Service Bulletin

Date: **24 January 2022**

Subject: **Reprogramming of E-Shock GPS Module code 8000C9312 (E5 version)**

Product: **All E5 models equipped with GPS modules code 8000C9312**

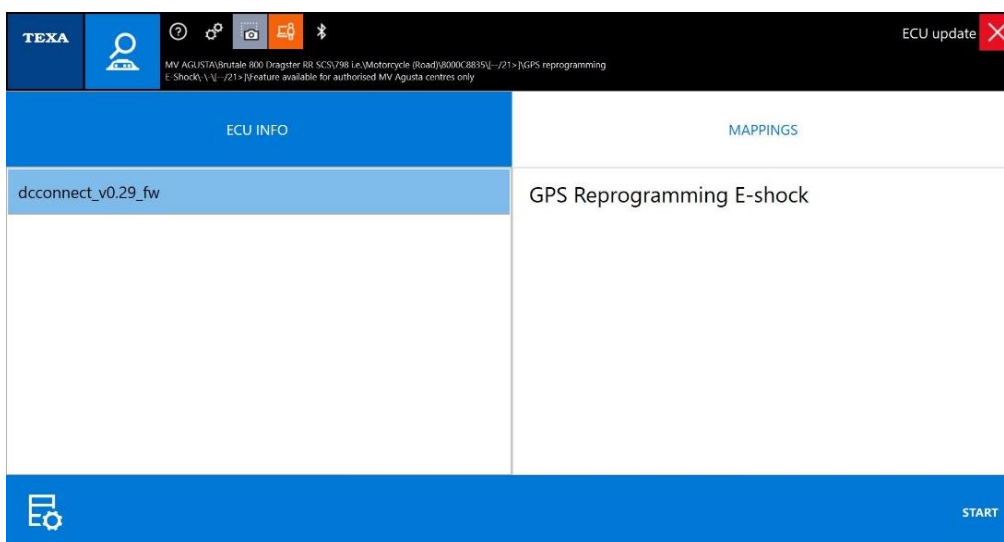
If the software version "v0.29" is already present, no further operations are necessary.
 If other software versions are present, proceed with the update following the procedure indicated below.

- Remaining in the "ECU UPDATE" environment related to the GPS module, go to the "MAPPINGS" section and select the new software named "v0.29". Press "START" to proceed with the loading of the new software:
